Application No: 09/409,627

For: METHOD AND APPARATUS FOR
DYNAMIC UNATTENDED NETWORK
CONFIGURATION OF AN
ALERT-BASED CLIENT

REQUEST TO APPROVE DRAWING CHANGES

FIGURE 2

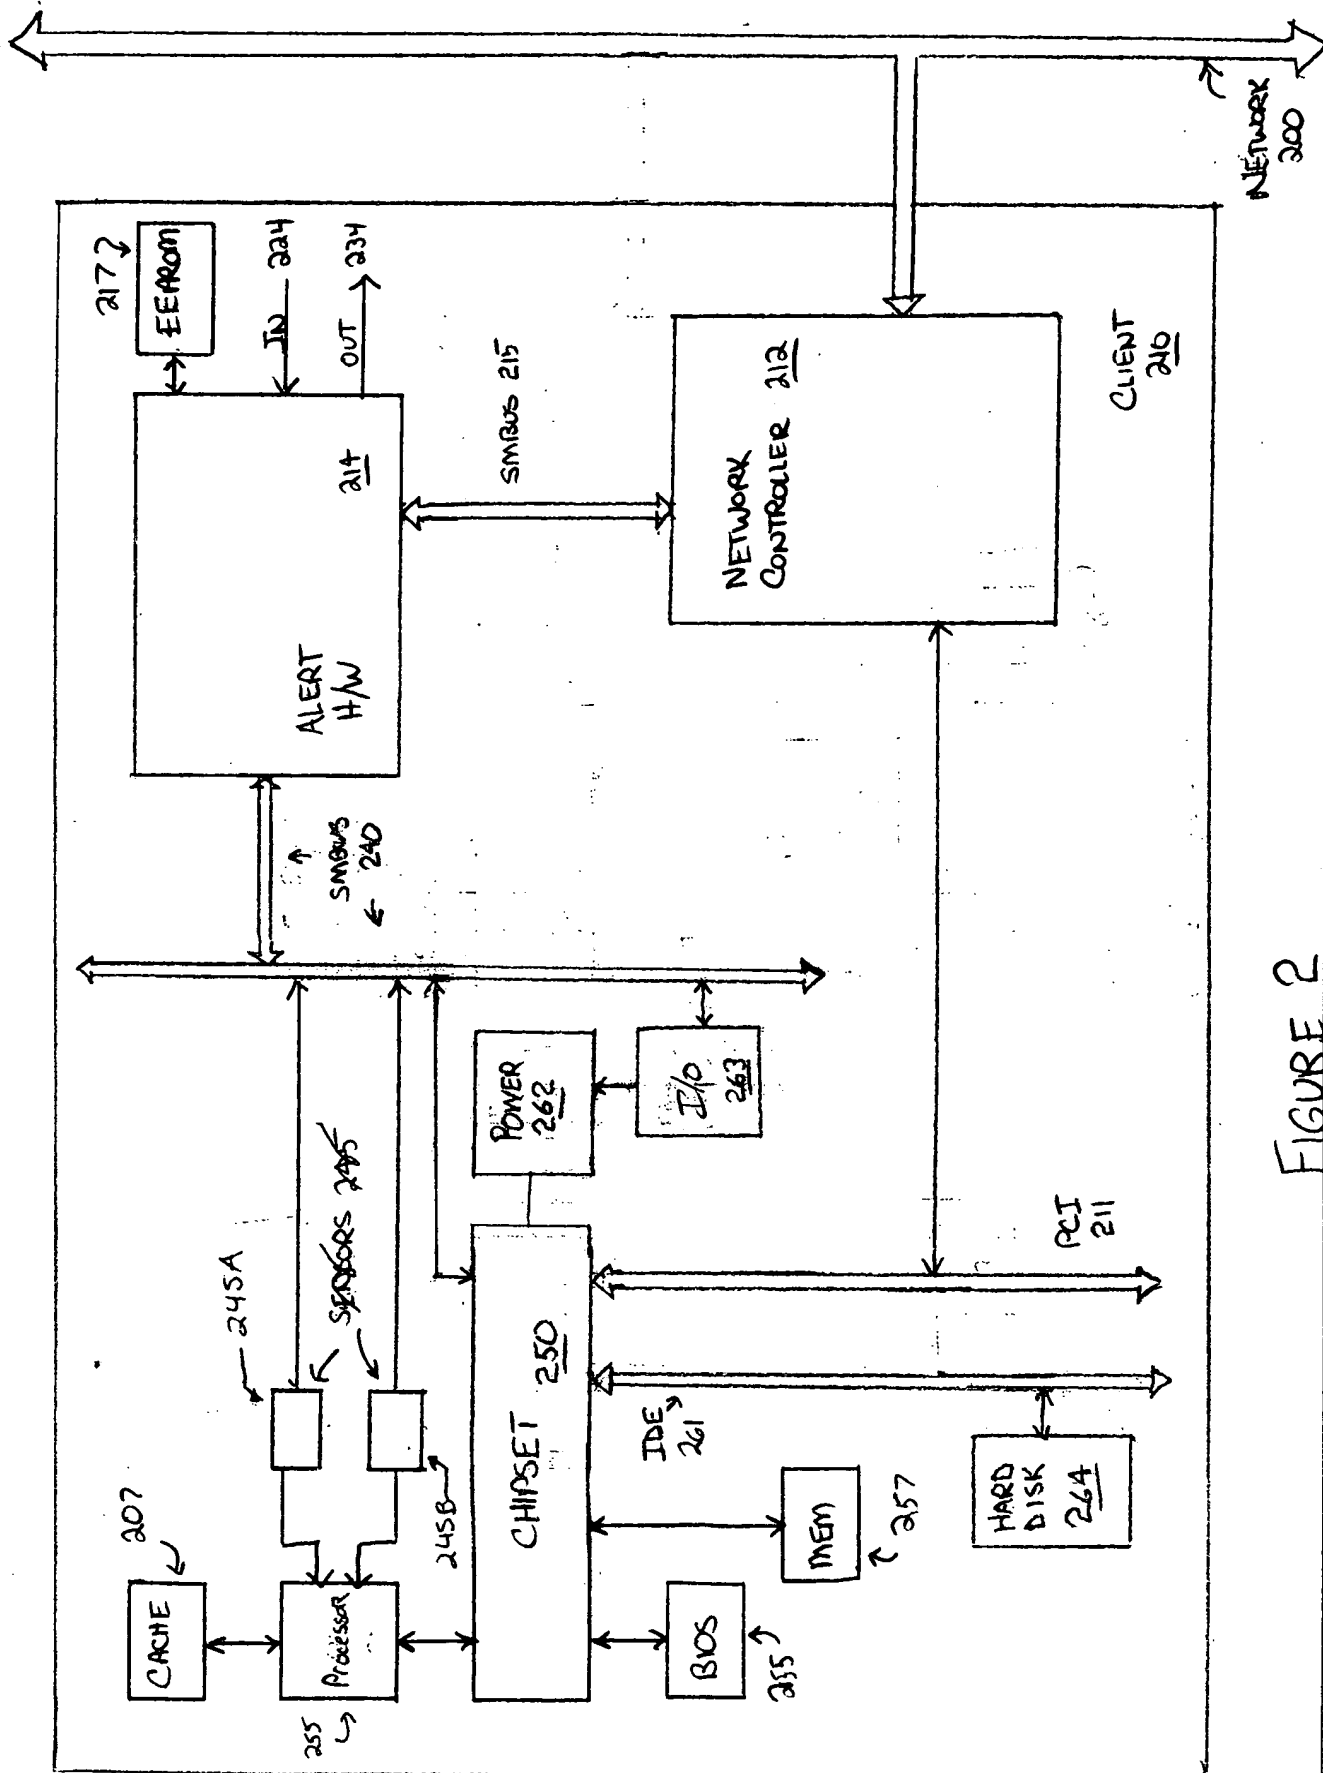
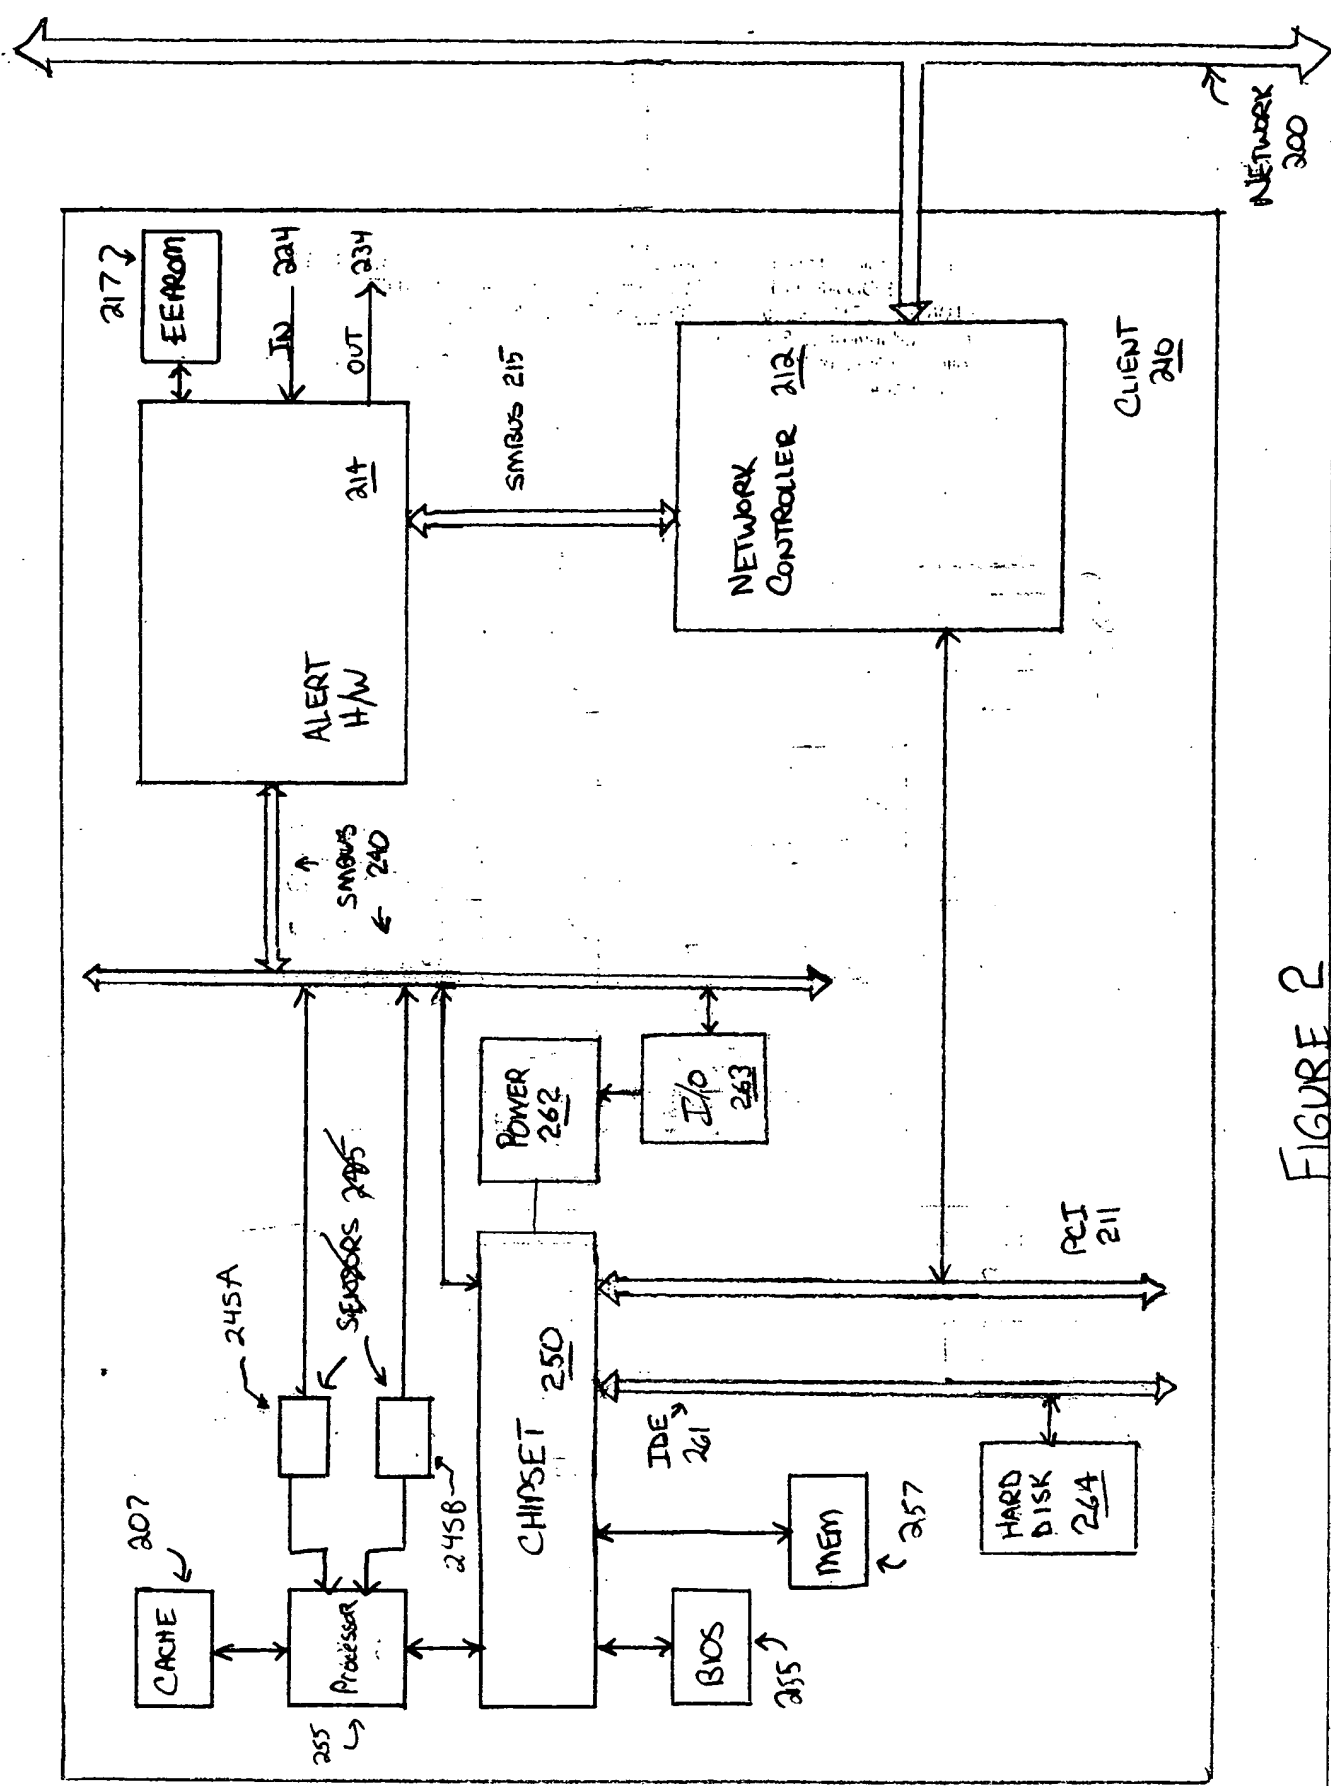
Enclosed is a photocopy of FIG. 2 and FIG. 6 with changes marked in red ink. A duplicate copy is provided. FIG. 2 has been amended so that one reference numeral does not point to two objects. FIG. 6 has been amended so that the reference numerals are consistent with the specification. Applicants respectfully request that the proposed changes in FIG. 2 and FIG. 6 be approved by the Examiner.
